United States Department of the Interior

March 6, 2007

REF: NUREG-1437 Supplement 30, draft
Vermont Yankee Nuclear Power Station
COMMENTS

Figure 1. Percent composition of numerically important species collected downstream of Vernon Dam [from Table 5-14 of the 316(a) Demonstration, April, 2004].

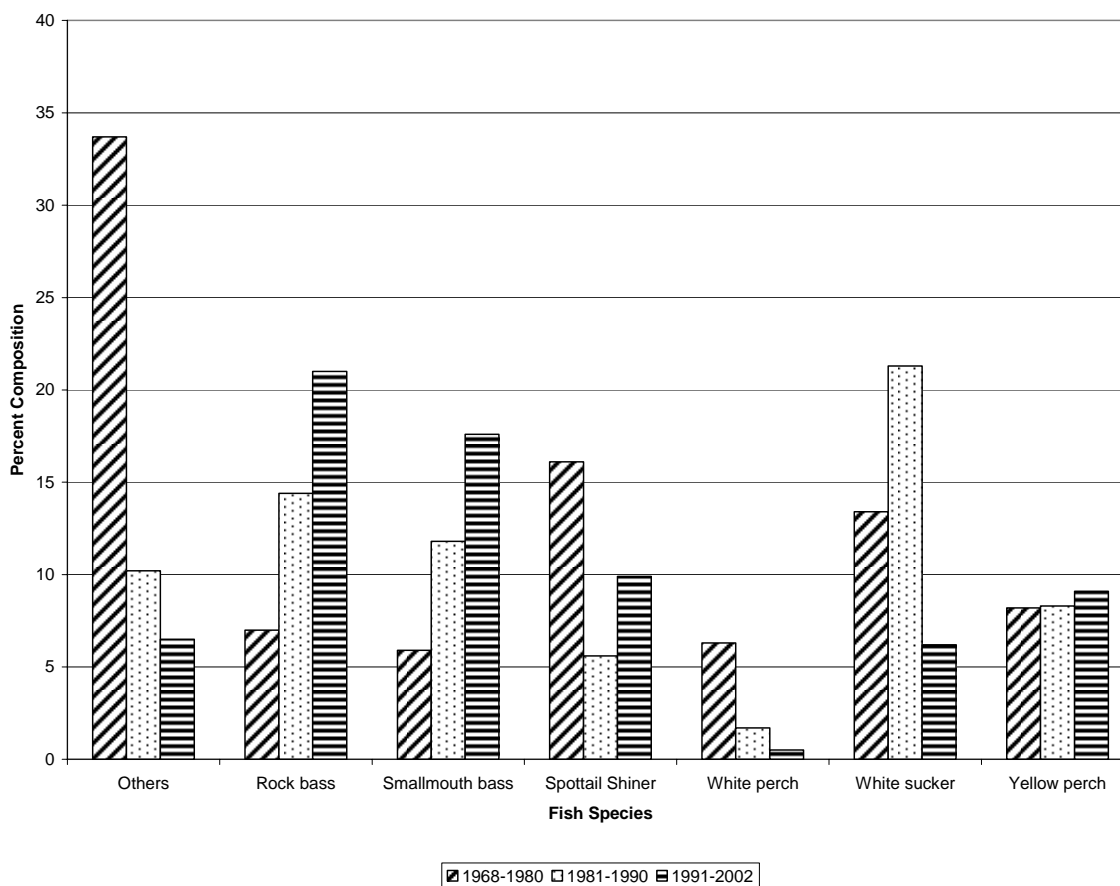
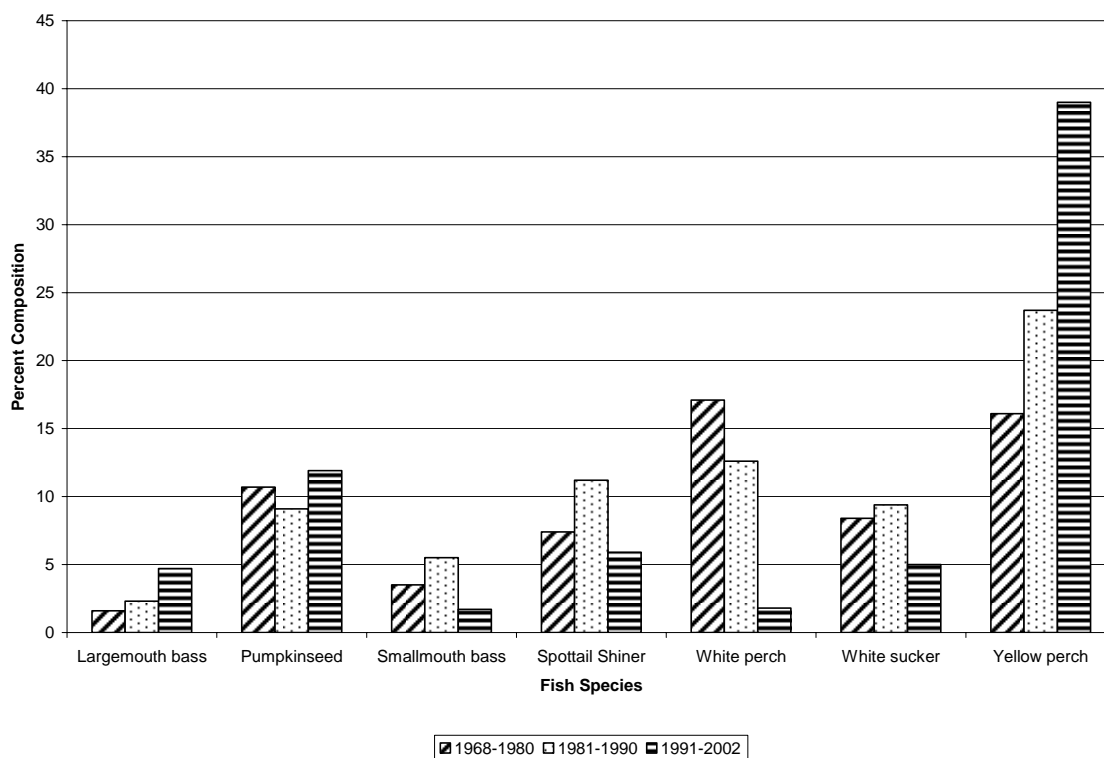
Page 4-17, lines 11-13: Although Entergy believes no observable adverse impacts to any fish species or to the overall fish community of Vernon Pool due to entrainment by VY has been demonstrated, the fact remains that Figures 1 and 2 above show a decline in the percent composition of white sucker and white perch in the LVP, and both of these species do show up in entrainment collections. Whether this relationship is causal or coincident is unknown.
